Working Draft
American National
Standard

Project
T10/1760-D

Information technology -
Serial Attached SCSI - 2 (SAS-2)

Summary of Comments on Serial Attached SCSI - 2 (SAS-2) Standard

Figure 9 — State machine conventions

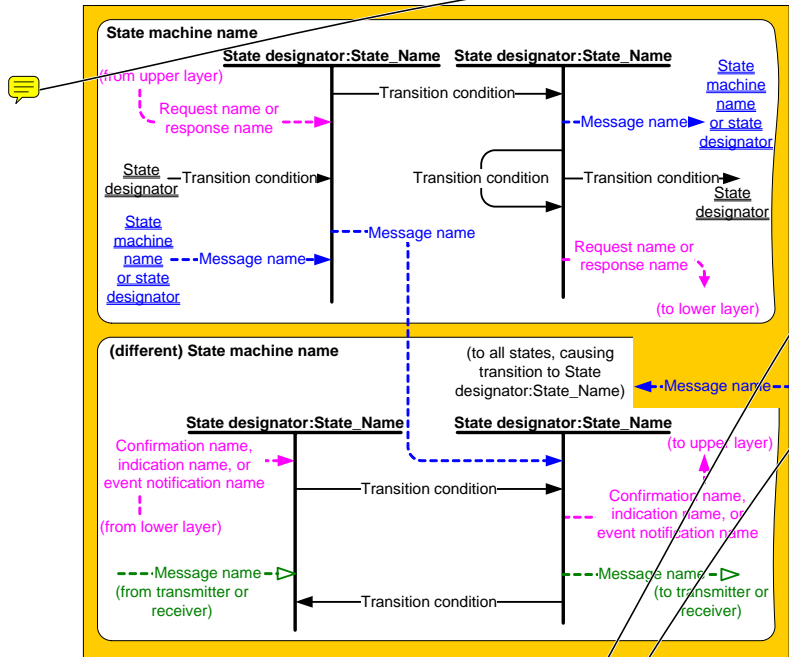
Figure 9 — State machine conventions
s/b
[Fix the squiggly lines on the right hand side of both inner boxes in the figure.]

label, a
s/b
label, and may include a

Figure 10 — SAS Domain class diagram

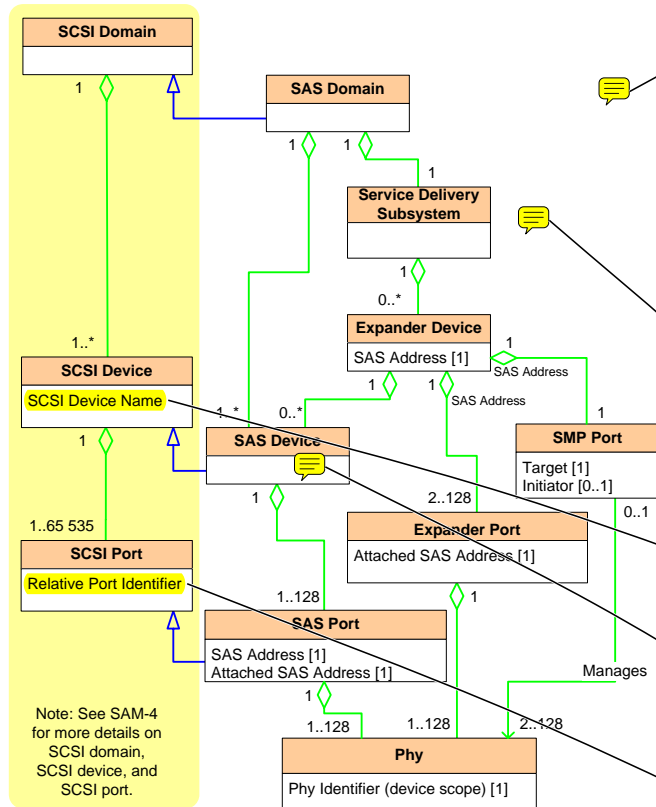
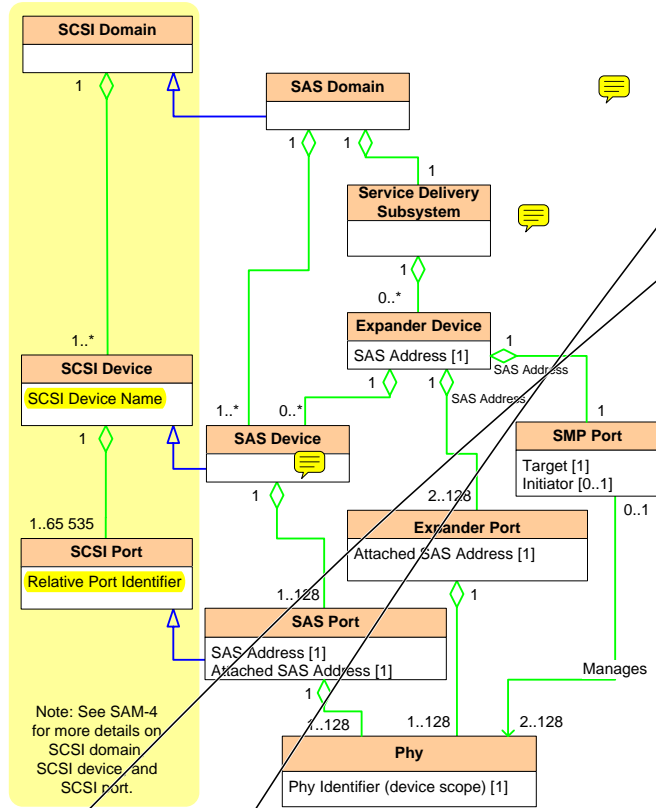
in figure 50, not table 50: 128 to 255, deleted two unnecessary sentences
 I suggest we increase the number of allowed expander phys to 255.

- Figure 10
- Figure 16
- Section 4.2.8 Phy identifiers shall be greater than or equal to 00h and less than 80h
- Table 8 (7-bit value)
- Table 50

figure 10: changed 1..128 to 1..255
 figure 10: changed 2.. to 2..255

figure 16: changed [0..128] to [0..255] (zero to 255 possible phys)
 figure 16: changed 2..128 to 2..255

also figure 38: 0..128 to 0..255
 also figure 38: 1..128 to 1..255
 also figure 39: 1..128 to 1..255
 also figure 39: 0..128 to 0..255

Figure 16 — Port class diagram

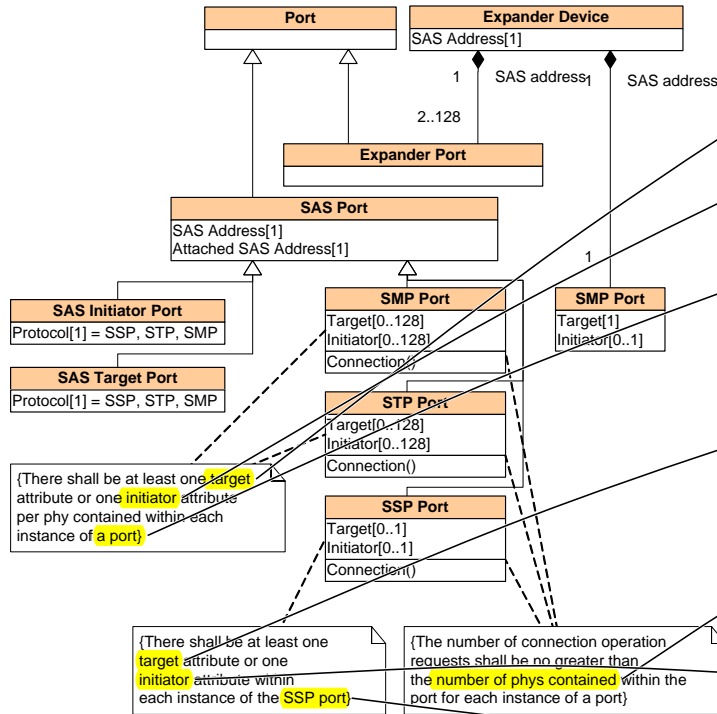
Should be << detail is not shown. However, each port

Figure 31 — Transmit data path in a SAS phy

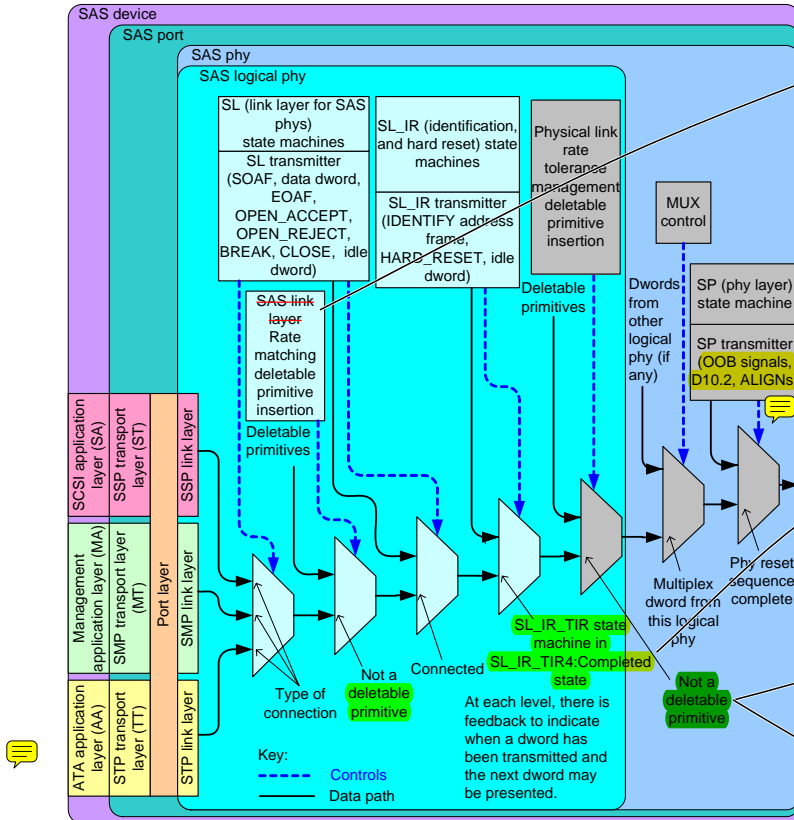
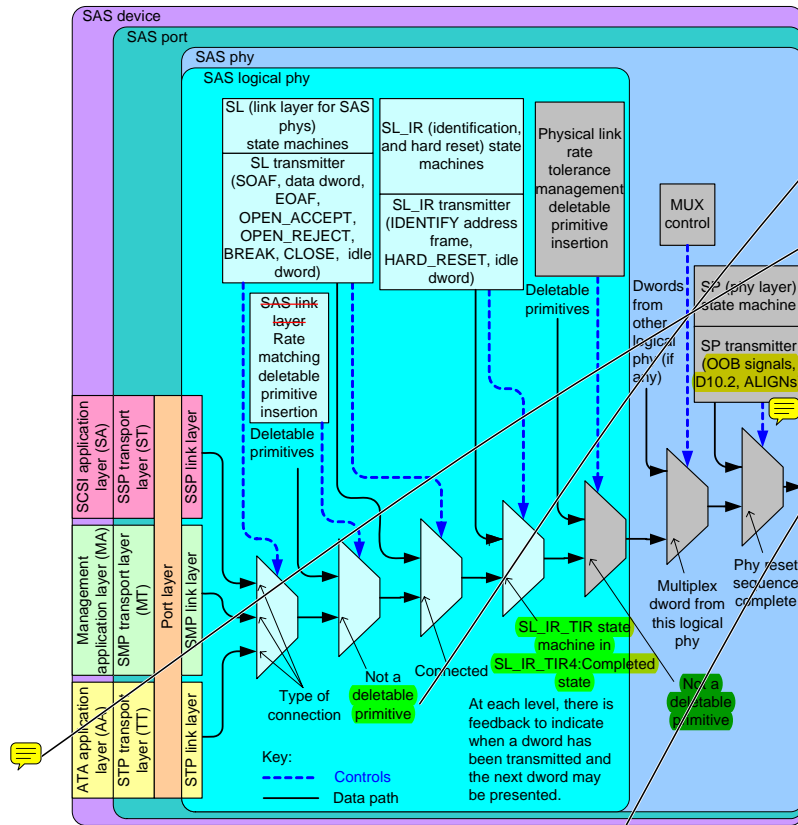
NOTE
s/b
Note

Figure 36 — Receive data path in a SAS phy

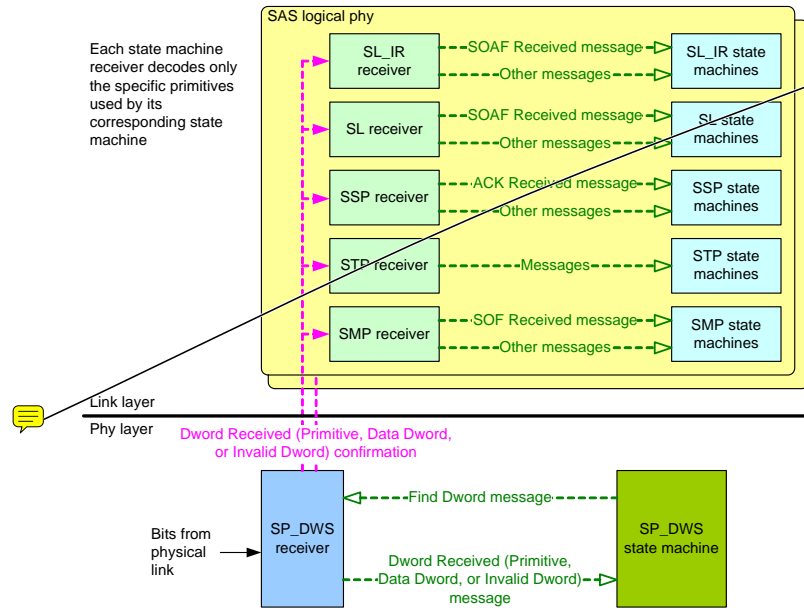
Add messages to figure 35 Receive data path:

1. Add message from the SW_DWS to SP_DWS receiver:
 Sync Acquired: this lets the SP_DWS receiver know when to start sending Dword Received confirmations to the link layer. Find Dword tells it when to stop.
2. Add the SP receiver and SP state machine
3. Add messages from the SP_DWS to SP receiver
 Sync Acquired: the lets it know when to start sending ALIGN Received, TRAIN_DONE Received, and Dword Received messages to the SP state machine
 Sync Lost: this lets it know when to stop sending them
4. Add messages from the SP state machine to the SP receiver:
 ALIGN Received
 TRAIN_DONE Received
 Dword Received
 Other messages

Figure 40 — Reset terminology

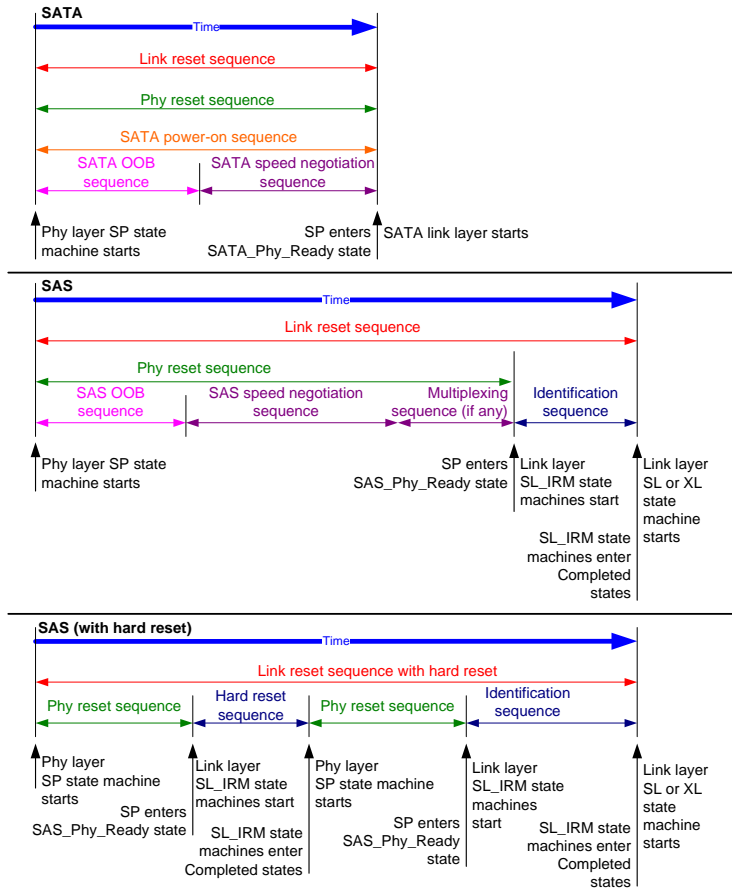
SP state machine... in 6.7 and 6.8
 s/b
 SP state machine and the SP_DWS state machine... in 6.7, 6.8, and 6.9
 because SP_DWS is also very involved

Figure 102 — SAS 4i and Mini SAS 4i cable assembly and backplane IT and IR compliance points

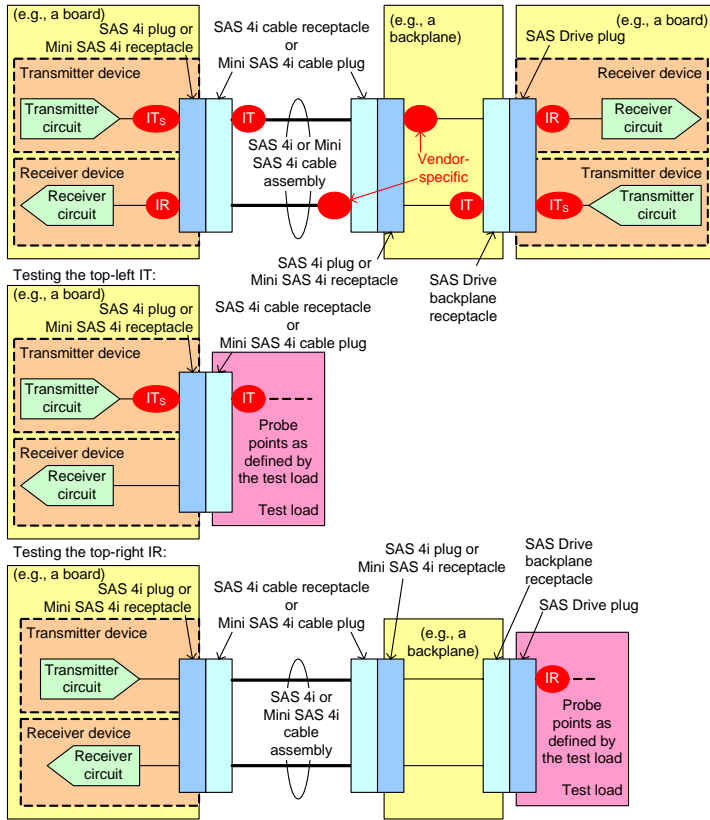
shows how two s/b how sets of two

Figure 104 — SAS Drive cable assembly IT and IR compliance points

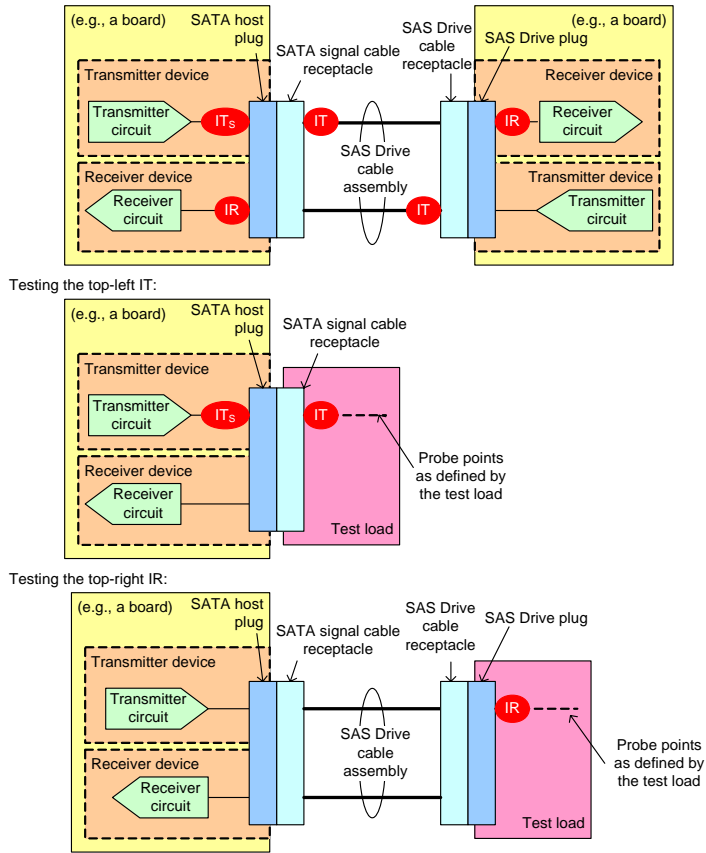
It
 s/b
 The figure

Figure 134 — SAS bit transmission logic

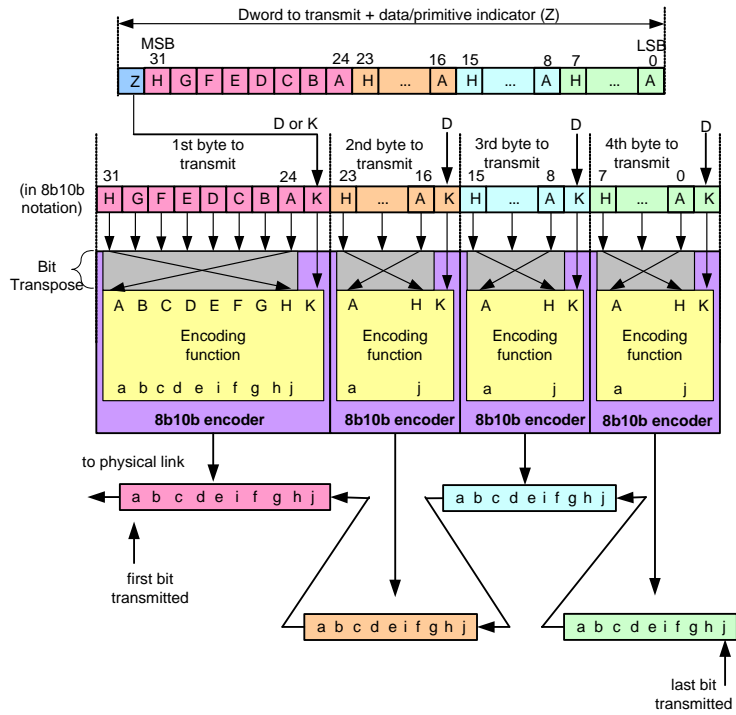
Author: wdc-mevans
Subject: Highlight
Date: 5/6/2008 4:07:48 PM
ACCEPT - DONE
order in
s/b
order shown in

Figure 155 — SP (phy layer) state machine - SAS speed negotiation states

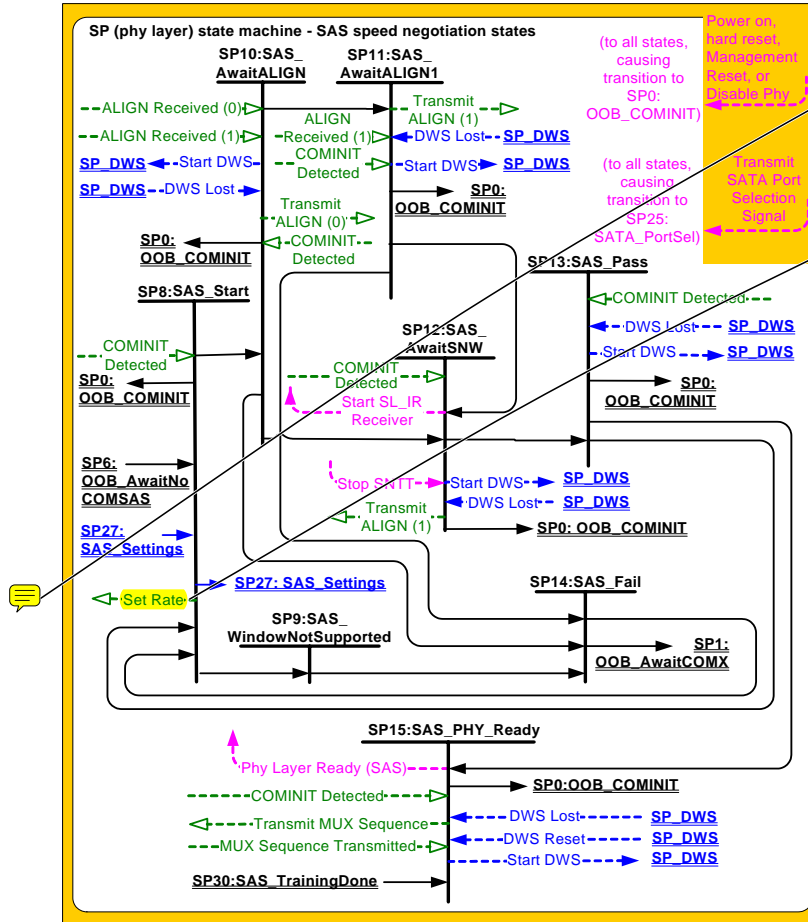
and performs
 s/b
 and the states in the state machine perform

Figure 157 — SP (phy layer) state machine - SATA host emulation states

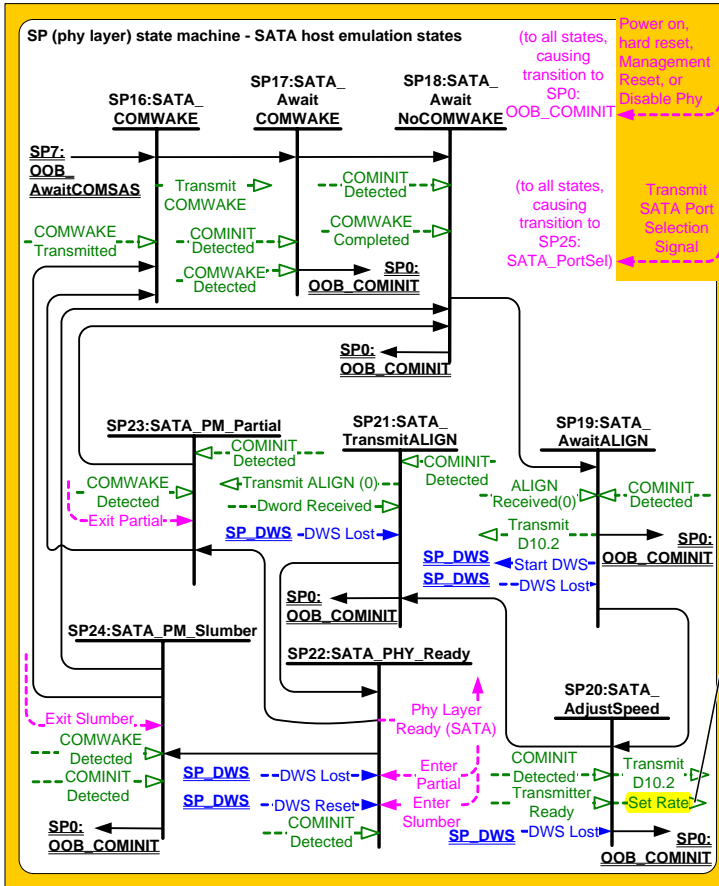
Set Rate
 Change to
 Set Physical Link Rate

Figure 184 — SL (link layer for SAS logical phys) state machines (part 1)

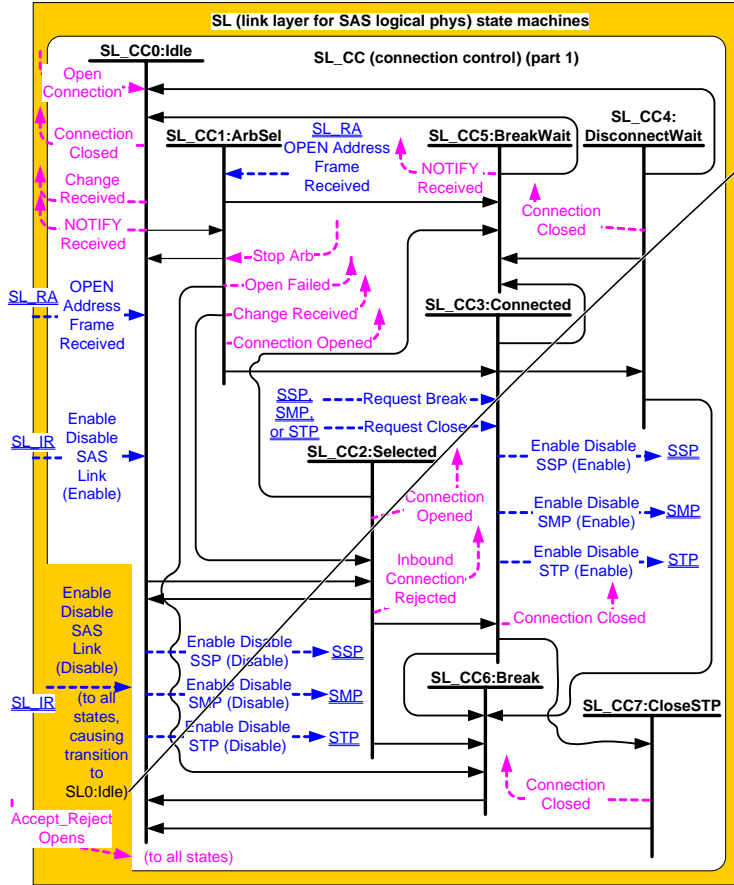
SL0:Idle
s/b
SL_CC0:Idle
